Project/Client: The Hall Senior School Hampstead London

Roof Details Sheet 03

Southern Boundary

Project No:			
IALN14-0046			
Dwg No:			
PL-103			
Rev:			
В			
 Scale:			
1 : 200	@A1		
Drawn By:	Date:		
СВ	20.05.16		
Checked By:	Date:		
JL	20.05.16

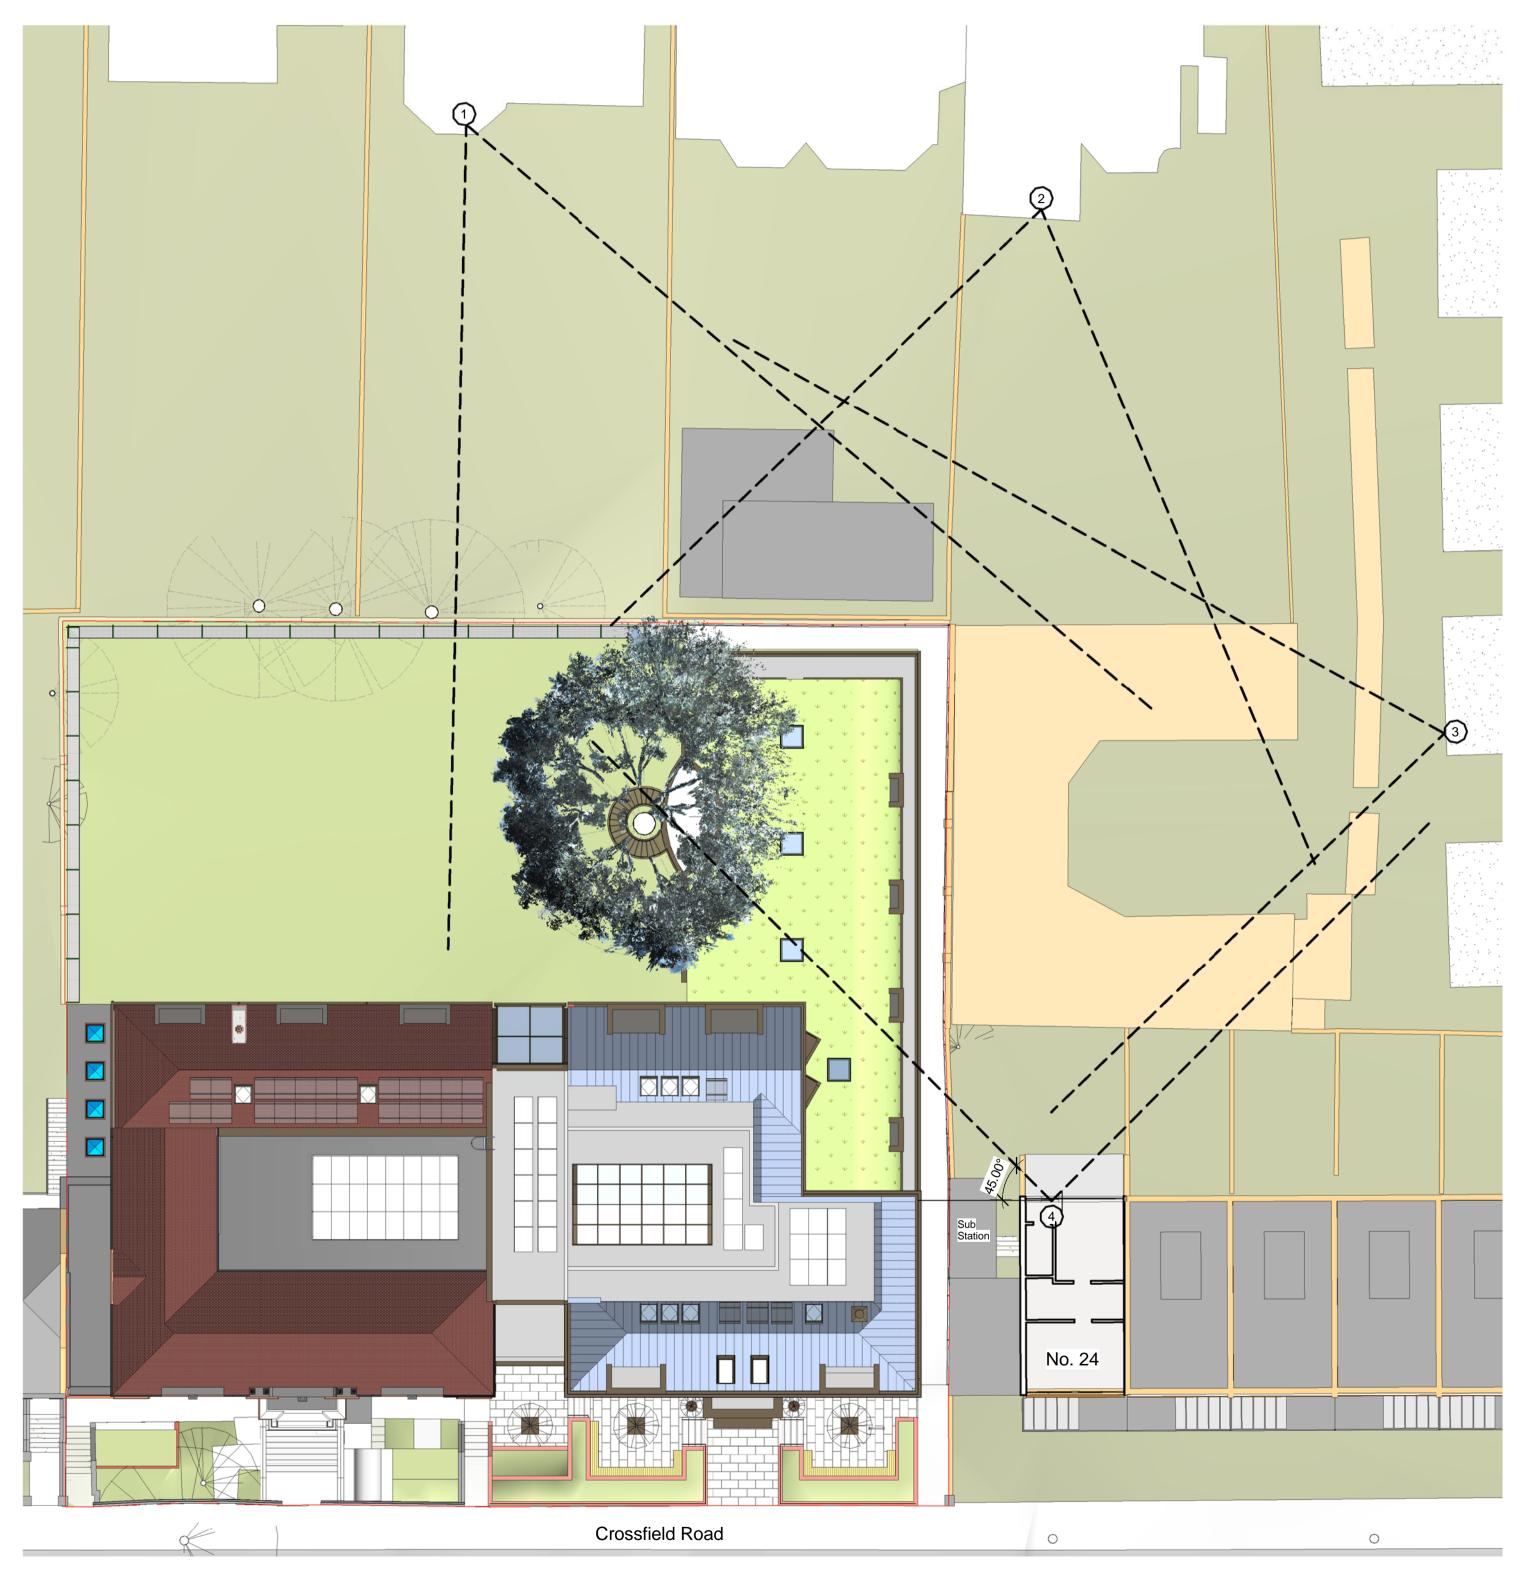
Design development to mitigate the impact on the heritage asset and neighbours to the north have resulted in an increase in massing on the southern side of the scheme. Care has been taken to mitigate the impact on neighbours.

Due to spatial constraints we are not able to reduce the mass of the rear corner by the external escape stair any further without compromising classroom sizes. However we have redesigned the escape stair so it is no longer external.

The massing of the addtional classrooms on the roof of the Wathen Hall has been reduced to the absolute practical minimum. The rear elevation is broken up with the zinc roofing material wrapped over the upper level, and further softened with vines grown on a wire trellis. The set back at this level creates an access balcony at this level for maintaining the plants.

The daylight and sunlight impacts on neighbours have been tested and are covered in the reports submitted with the planning application. All windows on the south elevation are either angled or obscured to avoid overlooking.
